Architectural Review Board Staff Report
August 10, 2026 Meeting

**6905 CENTRAL COLLEGE ROAD NEW HOME
CERTIFICATE OF APPROPRIATENESS AND WAIVERS**

LOCATION: 6905 Central College Road (PID: 222-000349)
APPLICANT: Old World Custom Homes c/o Patrick Miller
REQUEST: Certificate of Appropriateness with waivers
ZONING: Residential Estate District (R-1)
STRATEGIC PLAN: Residential
APPLICATION: ARB-36-2026

FRONT ELEVATION
SCALE: 3/16" = 1'-0"

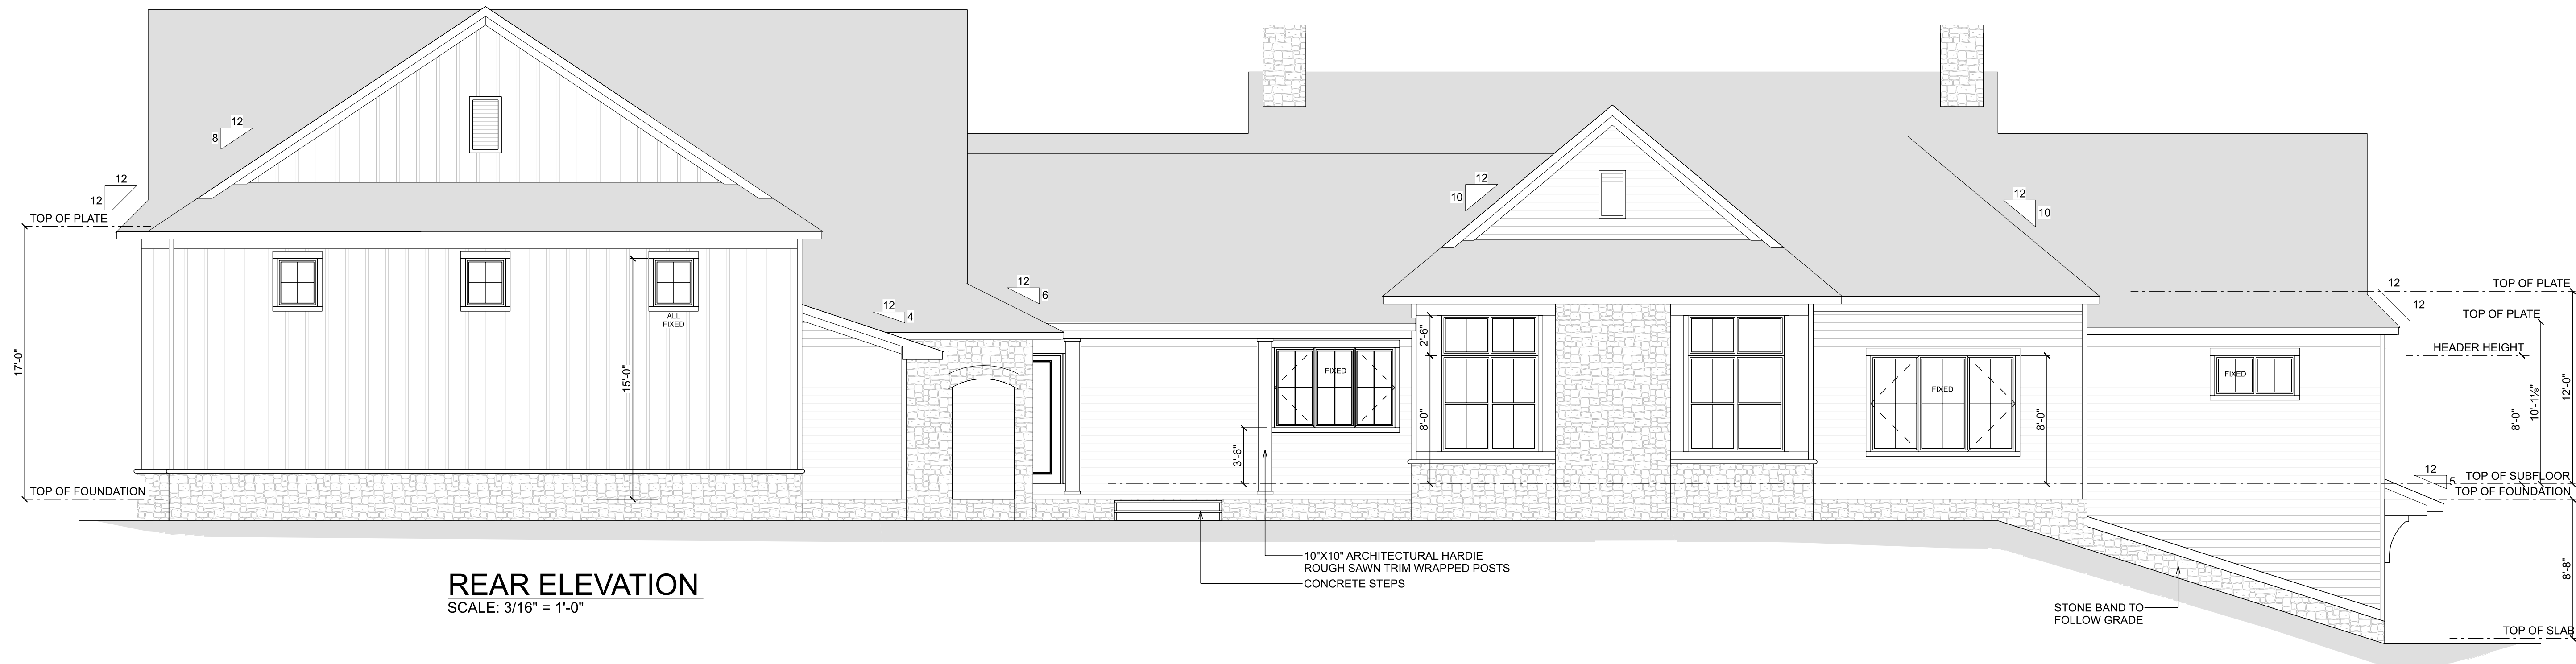
- The applicant added a turned gable at the end of the garage, running in the same direction as the main house mass. The new gable allows the overall garage mass to be reduced while “breaking up” the formerly long façade into elements with a more human scale. This gable allows the garage to appear more comparable to and cohesive with the main house mass.

- The left elevation of the garage mass was divided between the area with the new gable form and a newly inset “connector” between the main house and new gable. The applicant also proposes one double-bay garage door on the “connector” part of the façade (see waiver C), which further breaks up the former repetition and visual dominance of the full elevation. Additionally, there is a single shed roof dormer centered above the double-wide garage door, which helps ground the architectural strategy.

- Windows were added to the frontmost façade on the garage, facing the public right-of-way. As supported by the DGRs, the windows give this portion of the house the appearance of being “lived in;” the garage mass feels more human-scaled and as an active part of the rest of the house.

- The home was originally designed with four single-bay garage doors accessible from the front motor court. The city architect argues that, aesthetically, four individual garage doors off of the front elevation would be overwhelming; as such, he advocates the use of two single-bay garage doors under the new gable form and one double-wide door between the main house and new gable. The double-wide door is inset from the single doors and acts as a “connector” between the forms. The design of both single- and double-wide doors express the same proportional intent. Additionally, the applicant has centered a single shed roof dormer above the double-wide door, which grounds the architectural strategy. The architect is highly supportive of the new configuration.

1. The porch roof will match the pitch of the two adjacent roofs.
2. The glass transom will be included on the garage doors.
3. The rear garage door area must be screened from the adjacent property, and landscaping must be installed along the west elevation, subject to staff approval.

LEFT ELEVATION
SCALE: 1/8" = 1'-0"

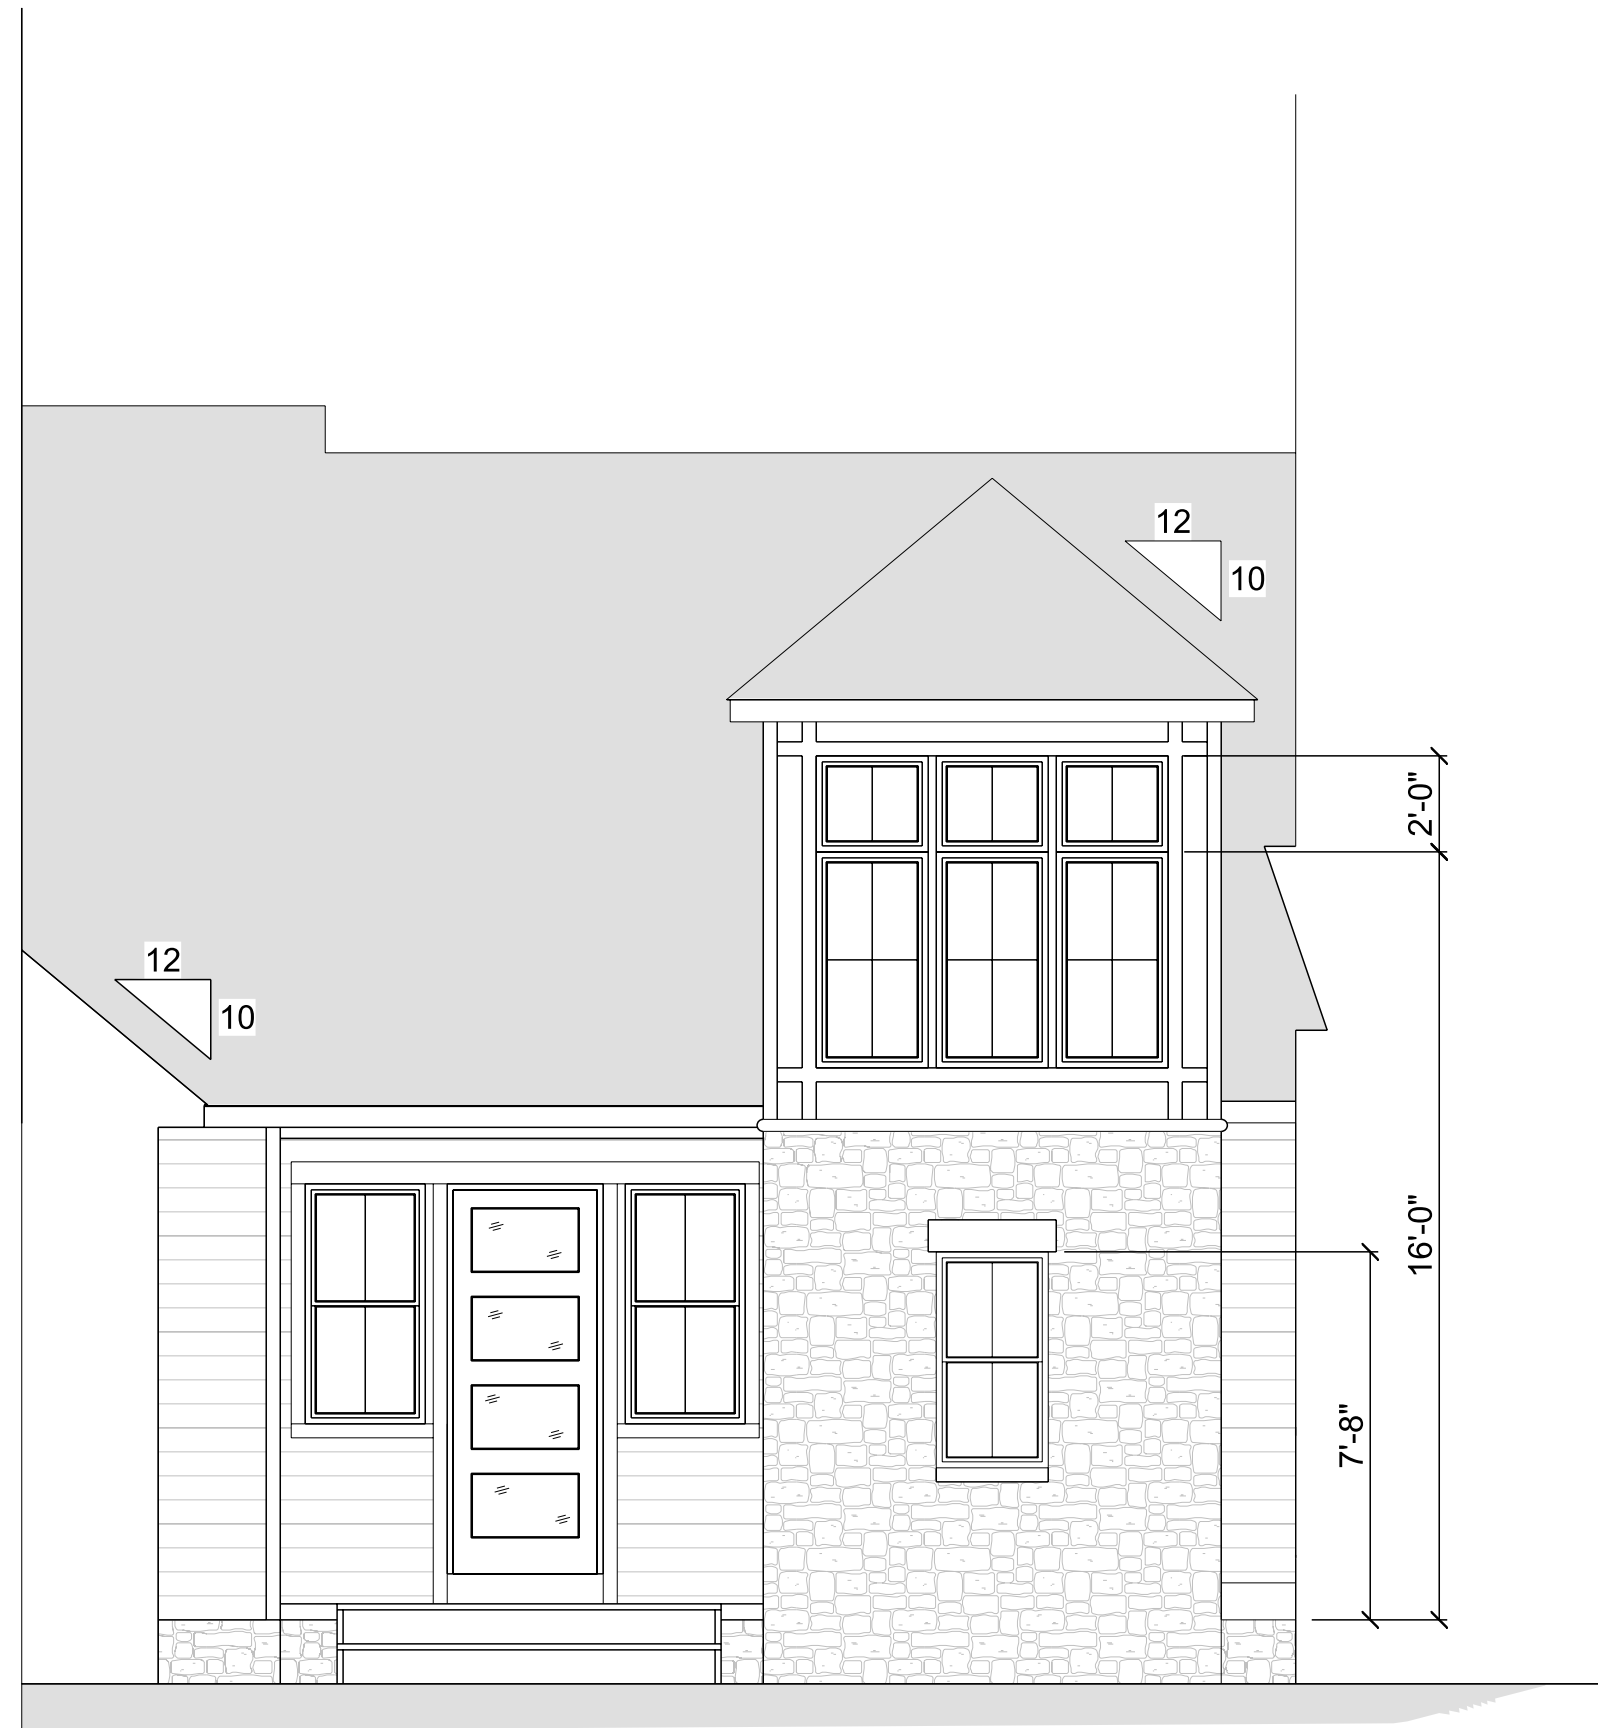
- Adding landscape screening to the gym mass's garage area.
- Adding faux windows or shutters to the gym mass and to the garage mass on the west elevation.
- Simplifying the roof condition on the west elevation.
- Continuing the eave over the gym mass from the garage façade to add a horizontal detail.
- Projecting the gabled form on the west elevation of the gym mass.

The applicant has made updates to the west side elevation that align with the Board's requests; however, the roof was not able to be lowered due to the internal configuration of this portion of the house. As an alternative way to reduce the impact of the gym mass, following discussions with the city architect, the gym mass of the building has been revised to appear more separate from and secondary to the main house by use of a barn design. As described in Section 1 of the DGRs for barns, the gym mass uses vertically oriented siding, a stone foundation, and gable rooflines. It also now features a continued eave, a faux barn door, windows, and landscaping.

- No signage is proposed at this time.
 - A driveway extends along the western side of the house to a single garage door on the gym mass of the building. The west elevation meets the side yard setback requirements; however, it is somewhat close to the adjacent lot. Given its location, visibility, and scale, staff recommends a condition of approval that the rear garage door area be screened from the adjacent property and additional landscaping be installed along the west elevation, subject to staff approval (condition #1).

- Further updates to the west side elevation strengthen the architectural quality and character of the home. As requested by the Architectural Review Board, these updates include adding faux windows or shutters to the gym mass and to the garage mass on the west elevation; continuing the eave over the gym mass from the garage façade to add a horizontal detail; projecting the gabled form on the west elevation of the gym mass; and adding landscaping. The roof could not be lowered due to the internal configuration of the gym portion of the house. As an alternative method of reducing the impact of the gym mass, and following discussions with the city architect, the gym mass of the building has been revised to appear more separate from and secondary to the main house by use of a barn design. As described in Section 1 of the DGRs for barns, the gym mass uses vertically oriented siding, a stone foundation, and gable rooflines. It also now features a continued eave, a faux barn door, windows, and landscaping.

1. The rear garage door area must be screened from the adjacent property, and landscaping must be installed along the west elevation, subject to staff approval.
